**DAC 25/07/23 – 21 PARNELL PLACE NEWCASTLE EAST –
DA2022/00705 – MIXED USE - ALTERATIONS AND ADDITIONS TO
EXISTING HOTEL OR MOTEL ACCOMMODATION (NEWCASTLE
BEACH HOTEL), ANCILLARY FOOD AND DRINK PREMISES AND
COMMERCIAL USE (ANCILLARY HOTEL SPA) AND DUAL
OCCUPANCY (ATTACHED 2 X DWELLINGS)**

PARNELL PLACE

21 Parnell Place, Newcastle East, NSW 2300
LOT 1 /DP815595

DRAWING
 ELEVATIONS - SHEET 1

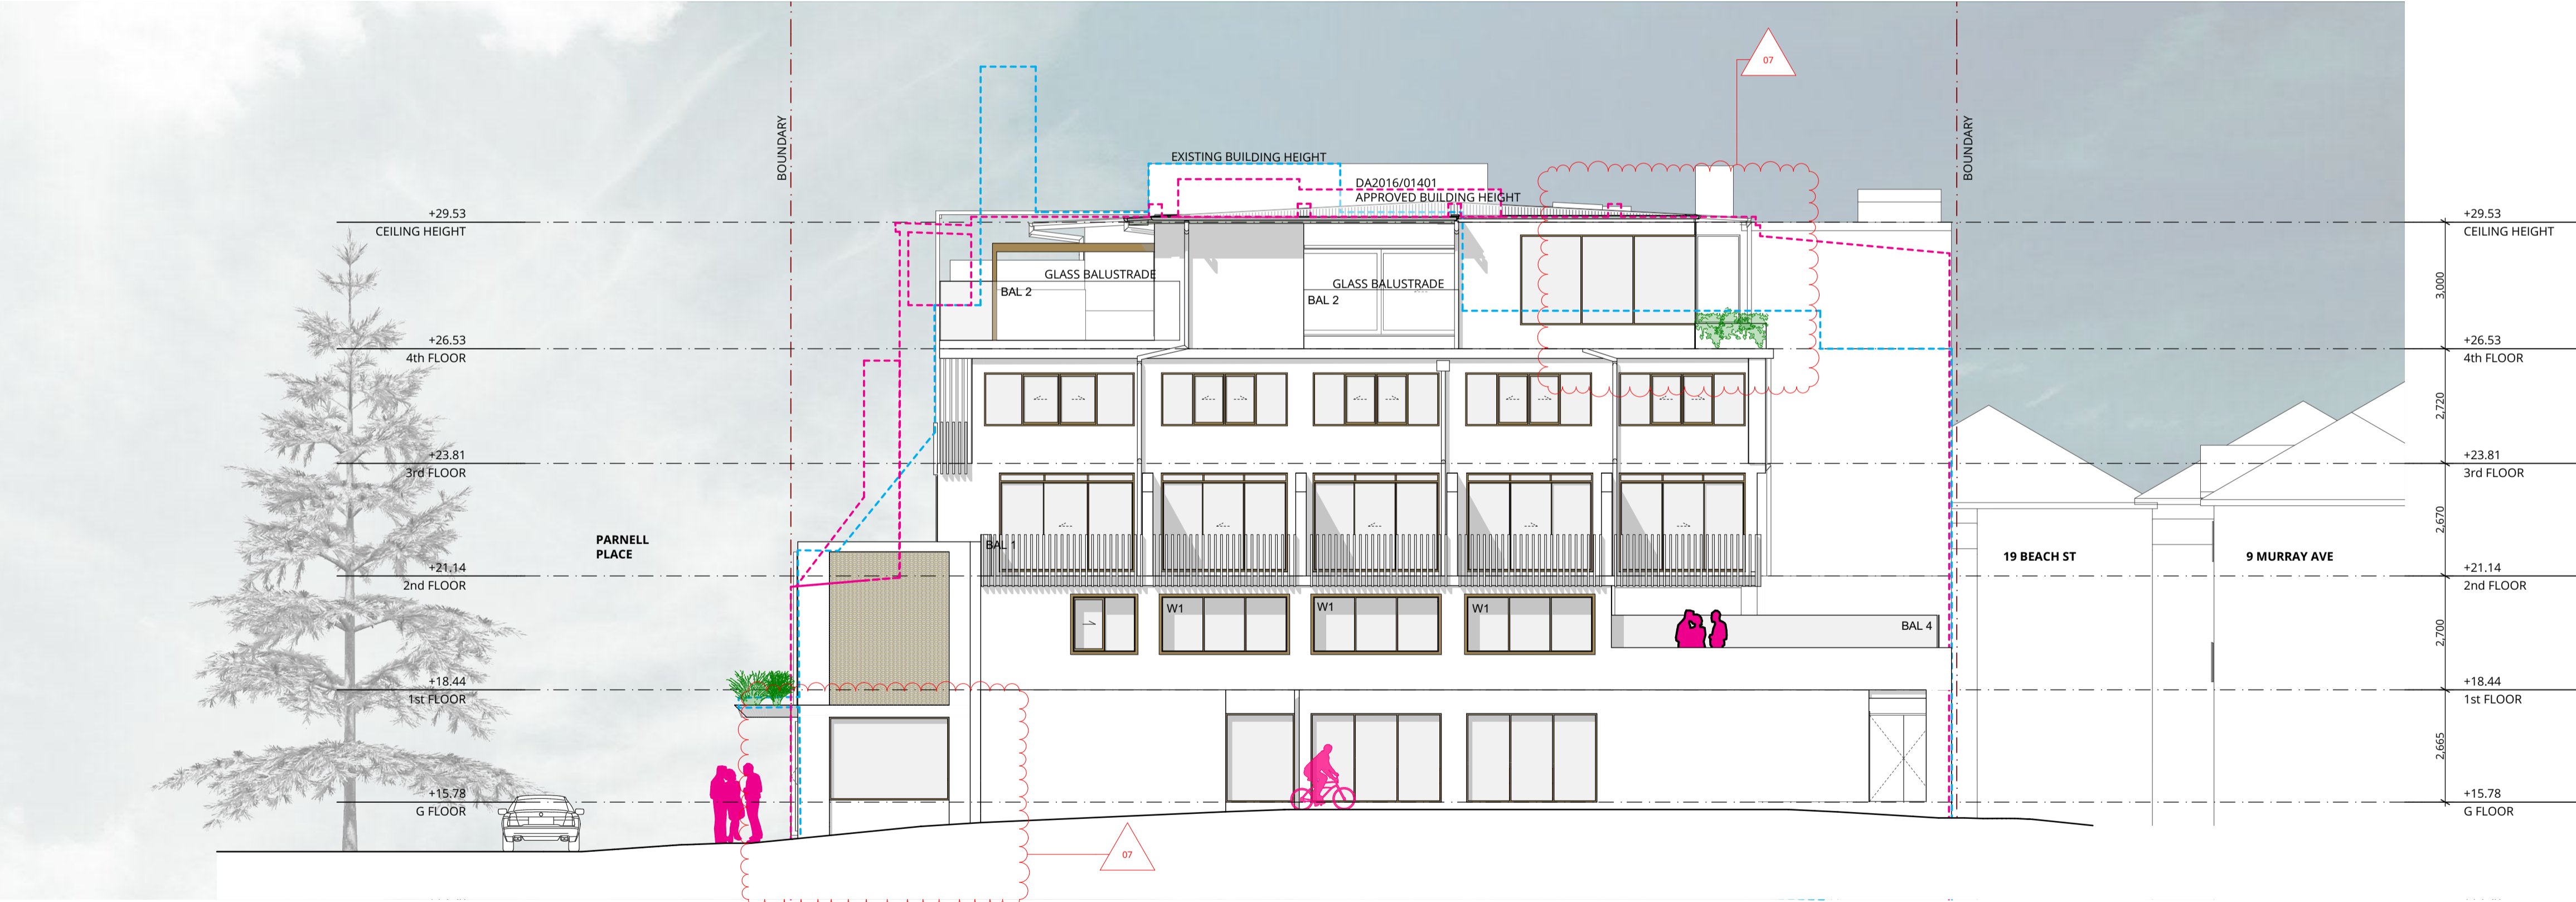
- RFI RESPONSE**
- HERITAGE**
- PENTHOUSE 2 SETBACK FROM SOUTH EAST CORNER BY 1200MM AND LOW GARDEN ADDED TO SOFTEN EDGE AND REDUCE BULK & SCALE
 - PENTHOUSE 2 MOVED 600MM TO WEST TO MAINTAIN FLOOR AREA
 - PENTHOUSE 2 EAVE REDUCED BY 600MM TO REDUCE SCALE
 - ADDITIONAL LANDSCAPING TO PENTHOUSE 01 NORTH-WEST CORNER
 - LEVEL 03 SIGNAGE ZONE REMOVED
- OUTDOOR DINING**
- STREET AND LANEWAY SEATING REMOVED, AND OPERABLE WINDOWS IN SOUTH WEST CORNER REMOVED AND REPLACED WITH FIXED GLAZING

DRAWING
 SHADOW DIAGRAMS -
 SHEET 1

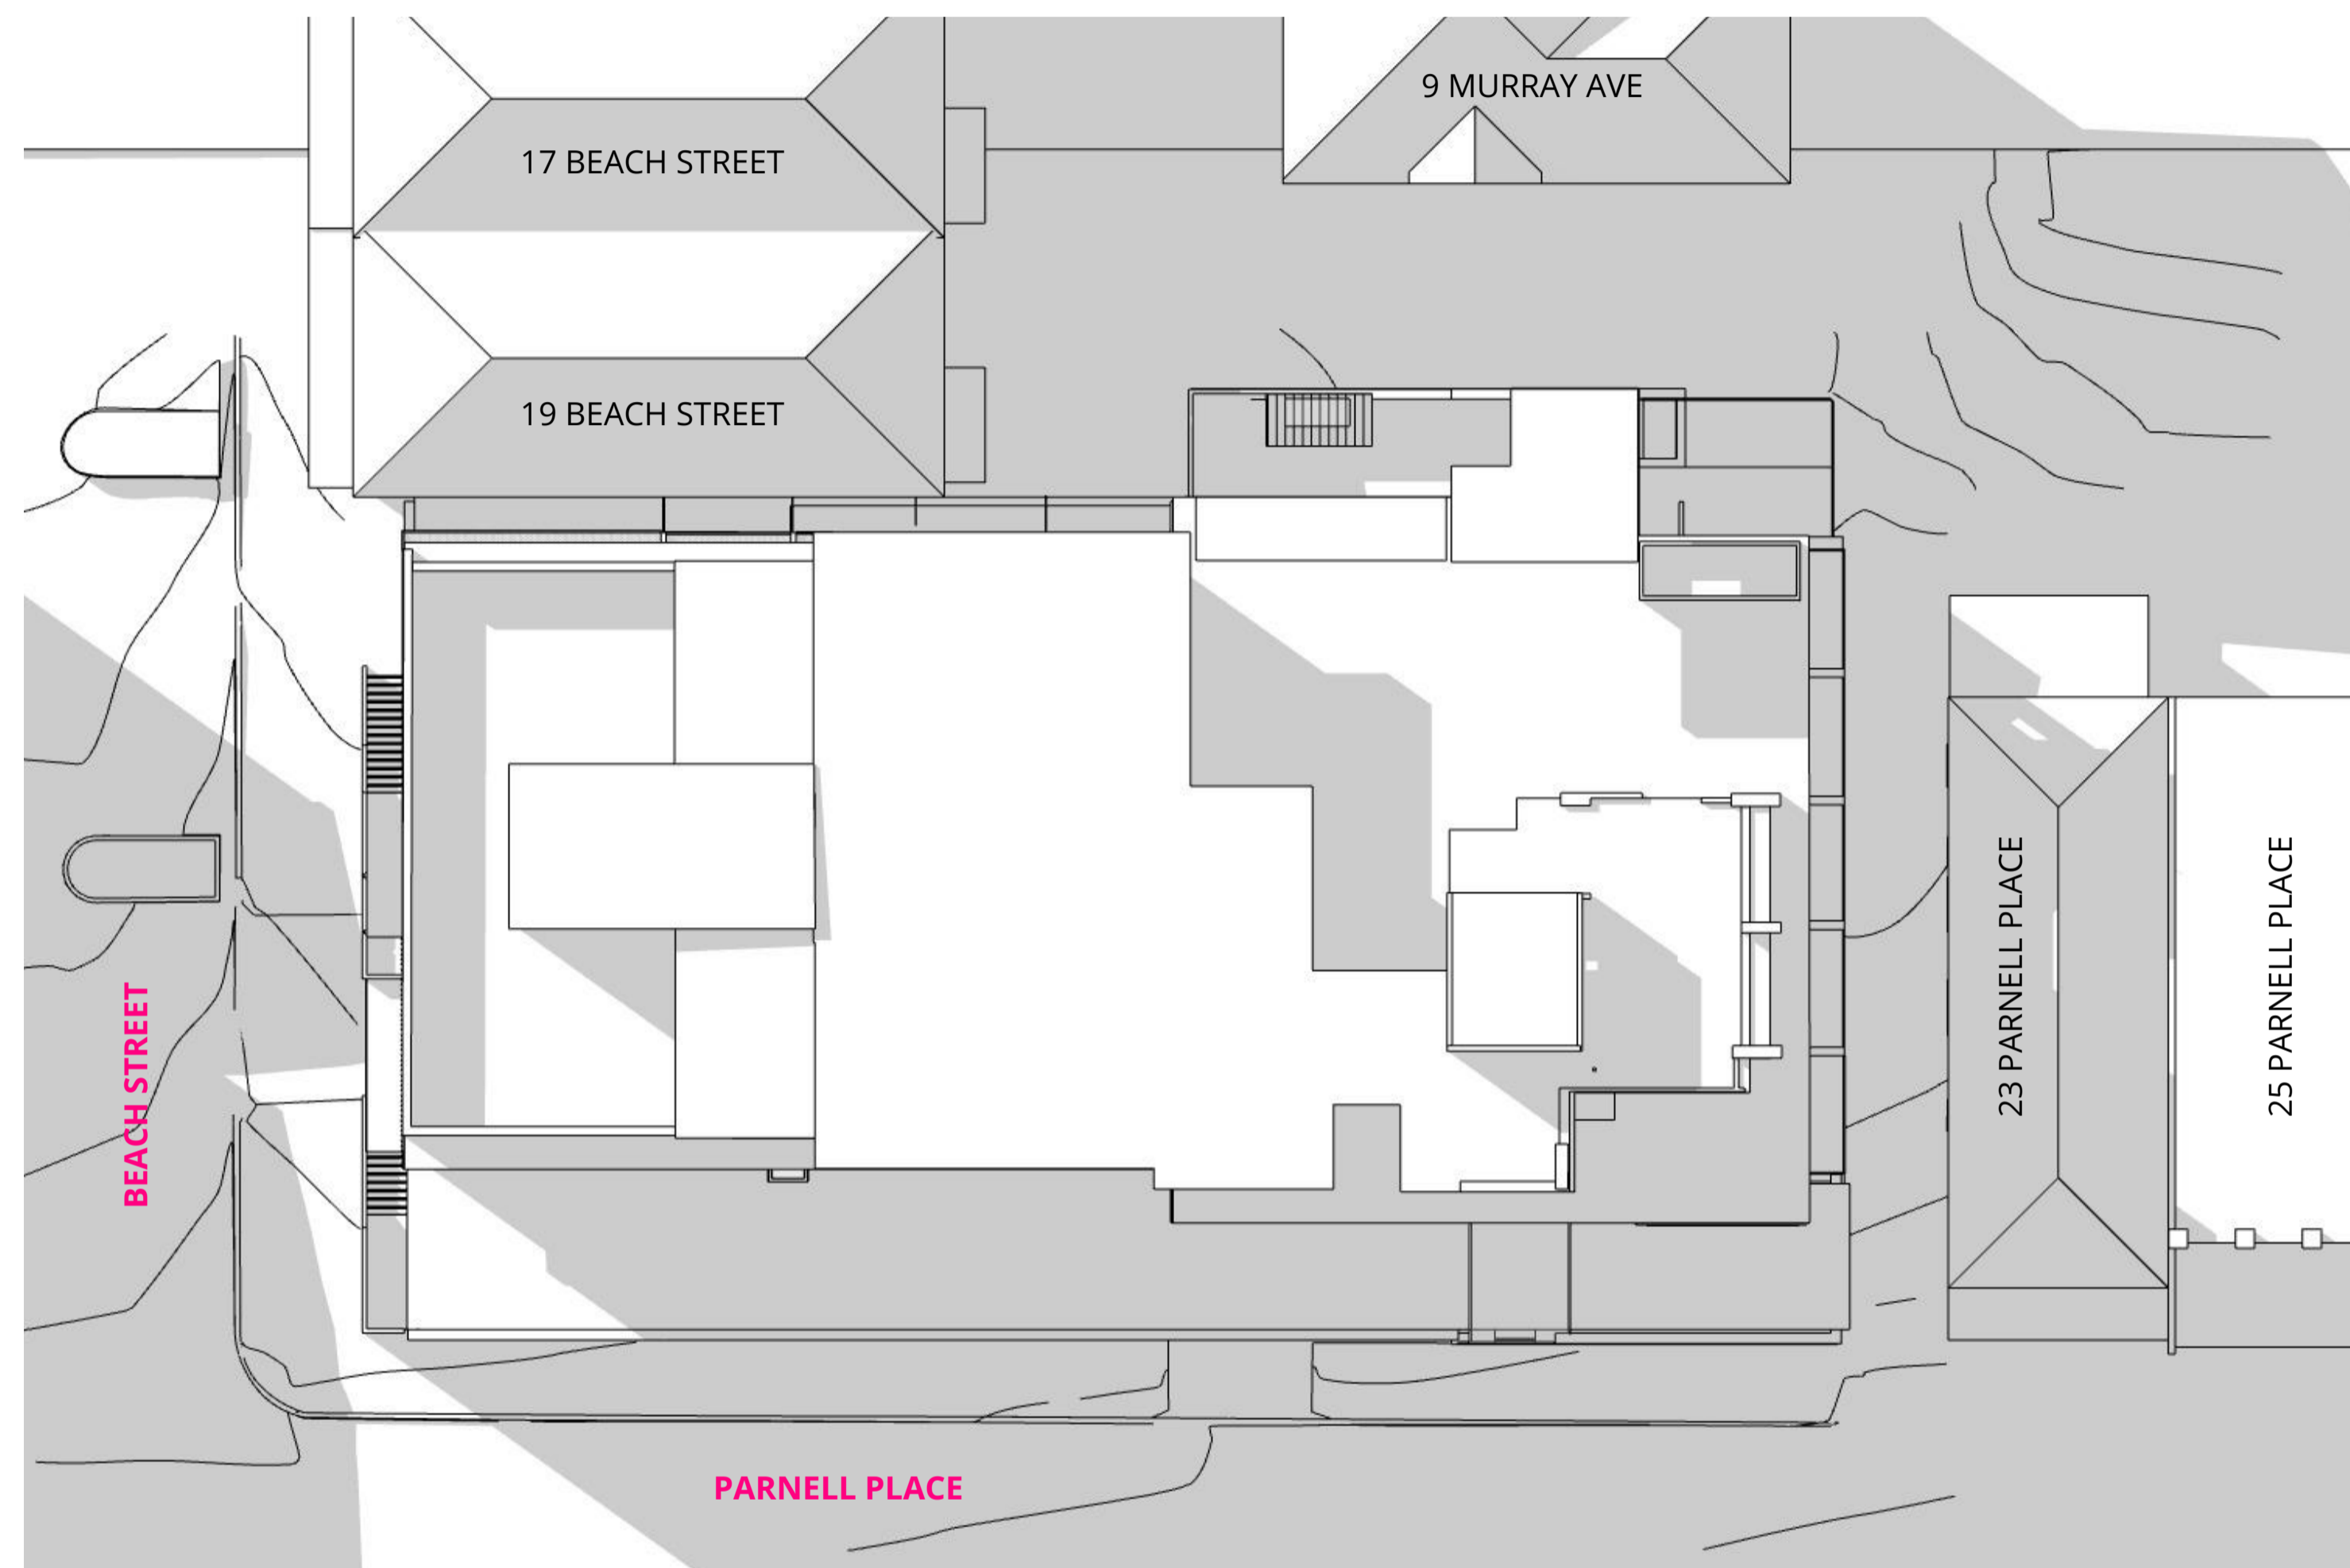
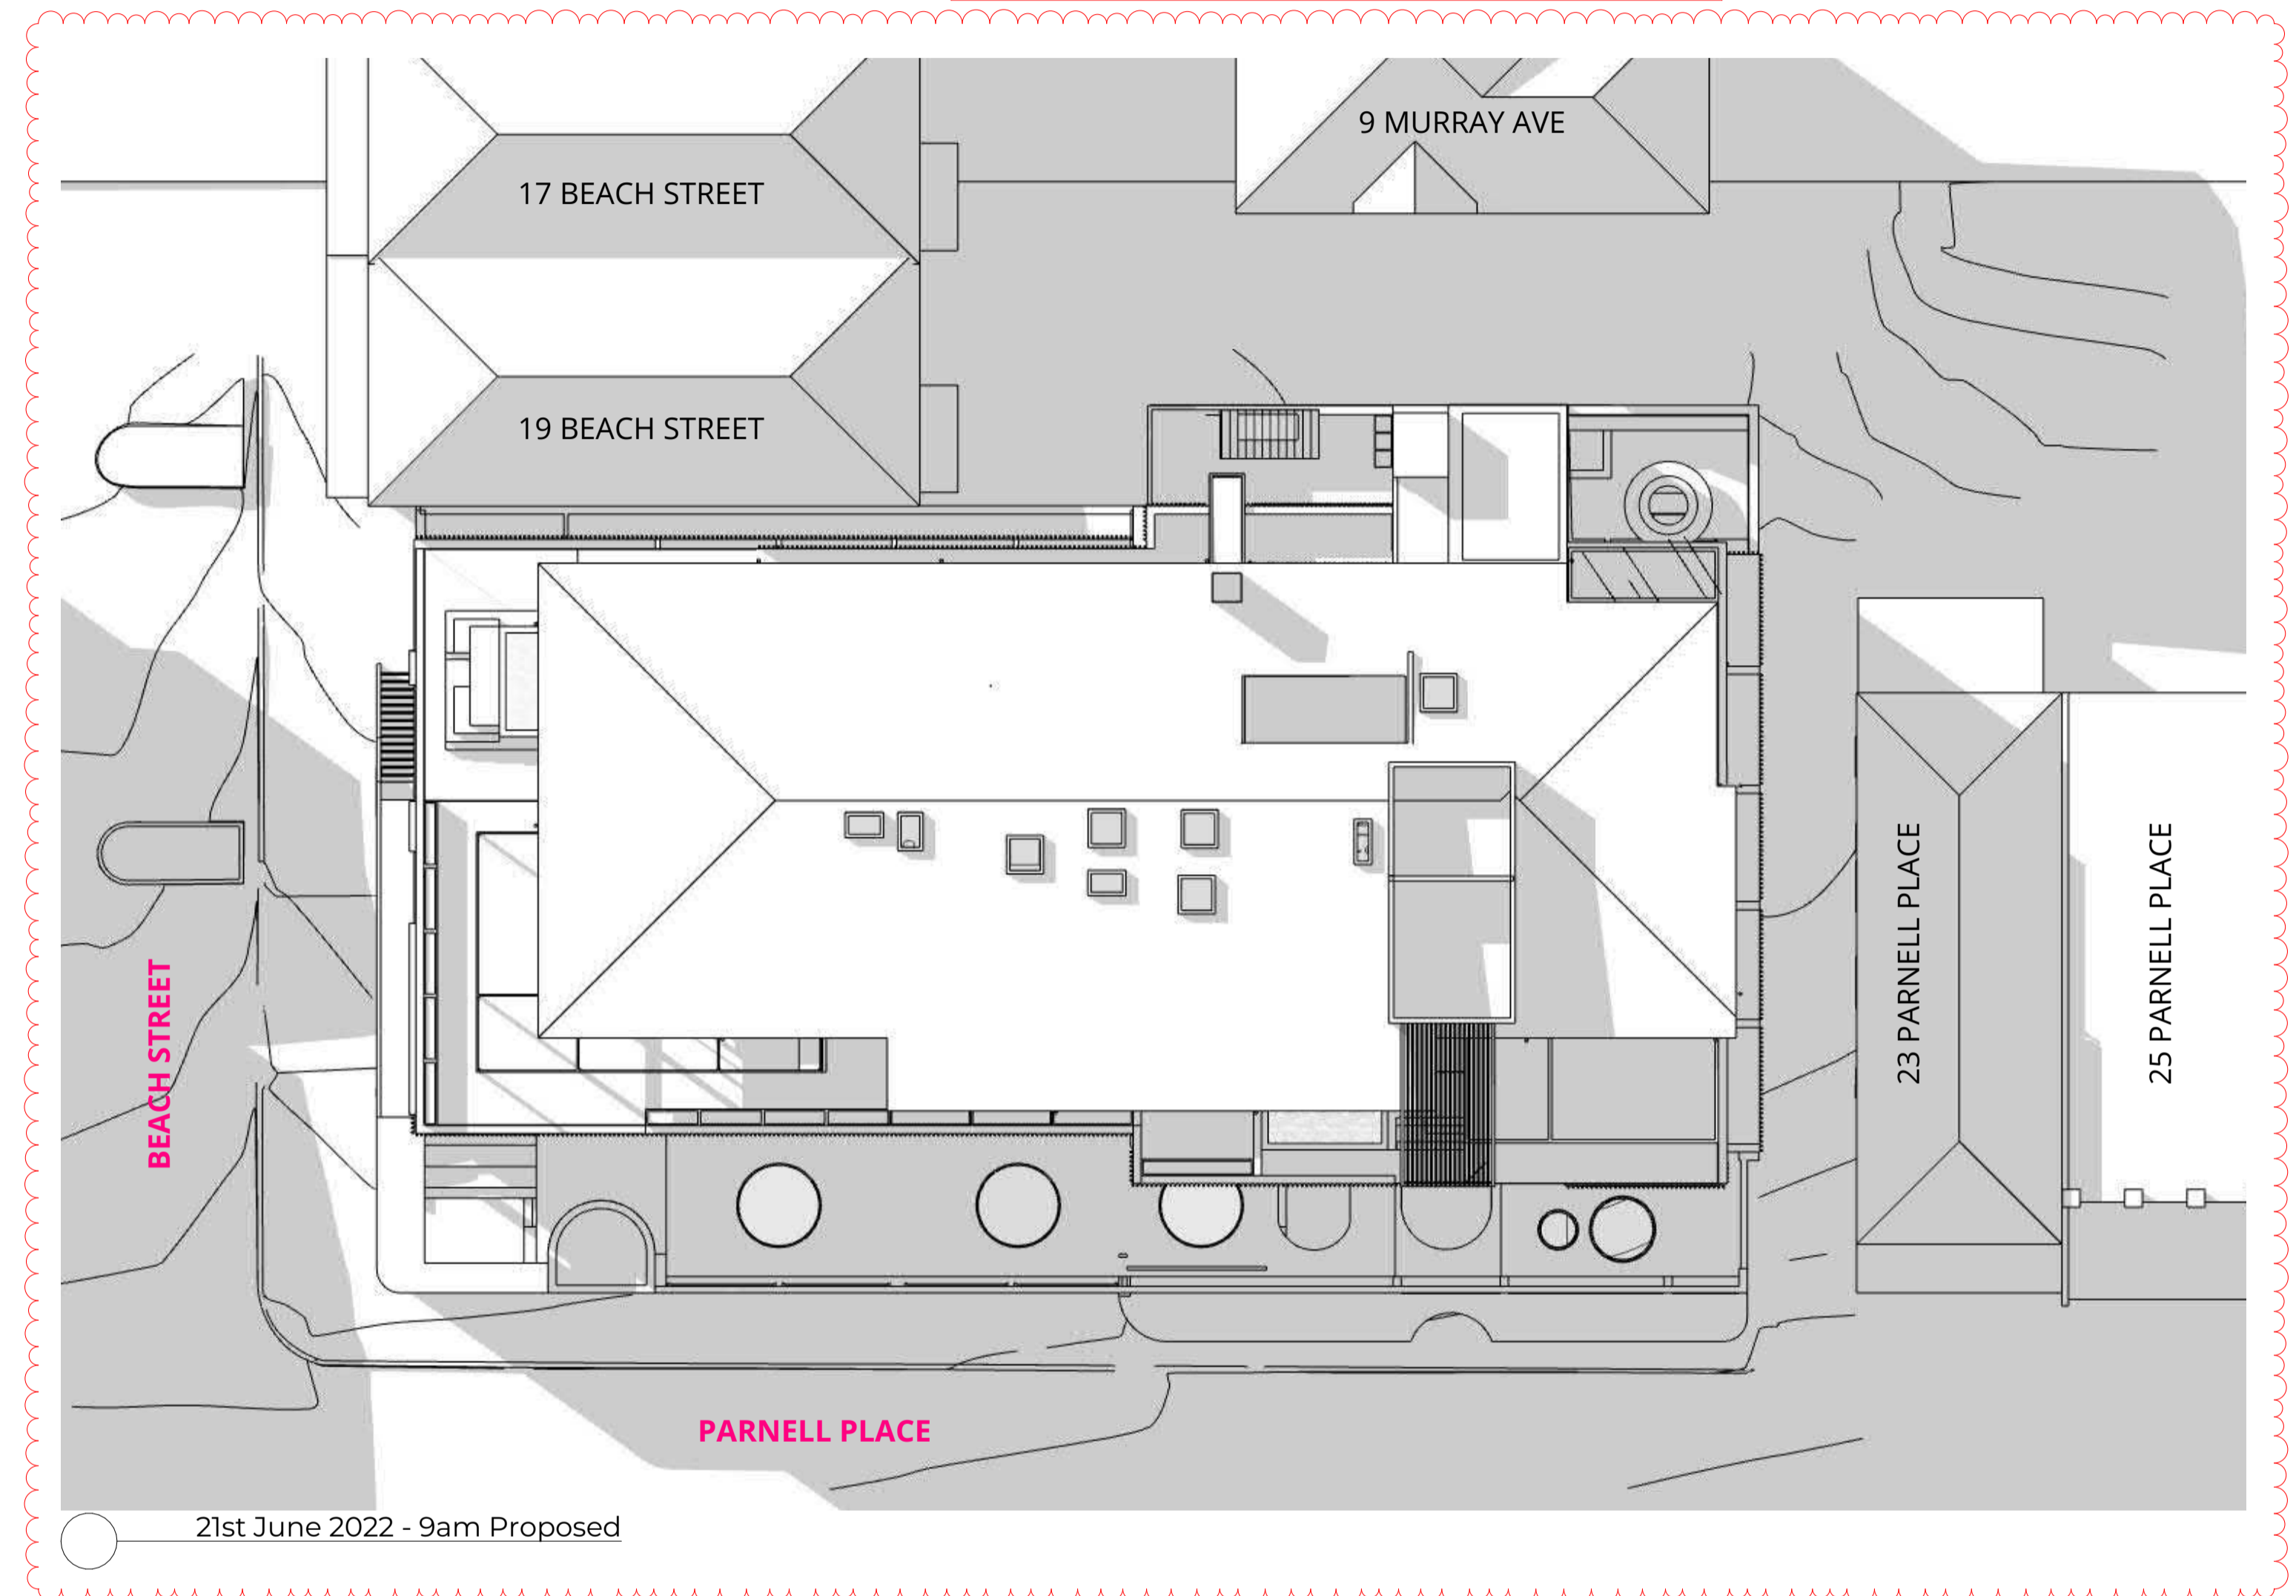
- PENTHOUSE 2 SETBACK FROM SOUTH EAST CORNER BY 1200MM AND LOW GARDEN ADDED TO SOFTEN EDGE AND REDUCE BULK & SCALE
- PENTHOUSE 2 MOVED 600MM TO WEST TO MAINTAIN FLOOR AREA
- PENTHOUSE 2 EAVE REDUCED BY 600MM TO REDUCE SCALE
- PENTHOUSE MOVED 600MM TO WEST TO MAINTAIN FLOOR AREA
- ADDITIONAL LANDSCAPING TO PENTHOUSE 01 NORTH-WEST CORNER
